BEAVER VALLEY POWER STATION, UNIT NO. 1

AMENDMENT TO FACILITY OPERATING LICENSE

Amendment No. 75  
License No. DPR-66

SAFETY EVALUATION BY THE OFFICE OF NUCLEAR REACTOR REGULATION  
RELATED TO AMENDMENT NO. 75 TO FACILITY OPERATING LICENSE NO. DPR-66

Figure 6.2-1  
Offsite Organization (Partial)

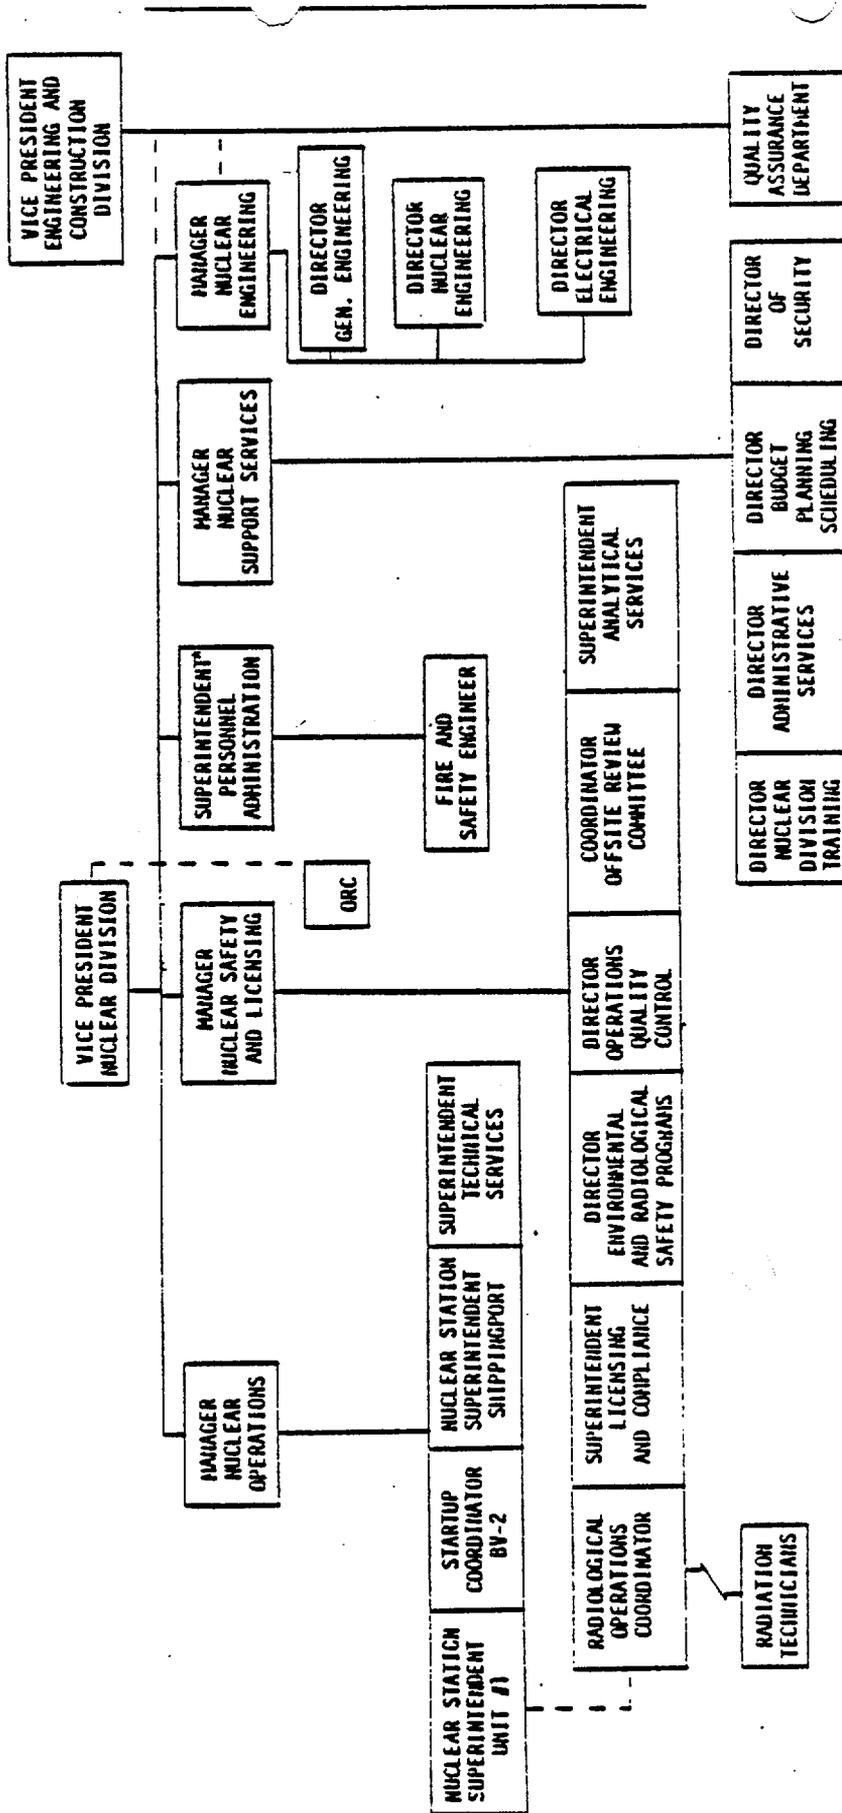
In addition, the licensee has requested that Figure 6.2-1 of the Technical Specifications be upgraded to include the organization under the Manager of Nuclear Engineering, and to change the job title of the Director of Personnel Administration to Superintendent, Personnel Administration. These changes are all administrative in nature, have no safety significance, and are thus acceptable.
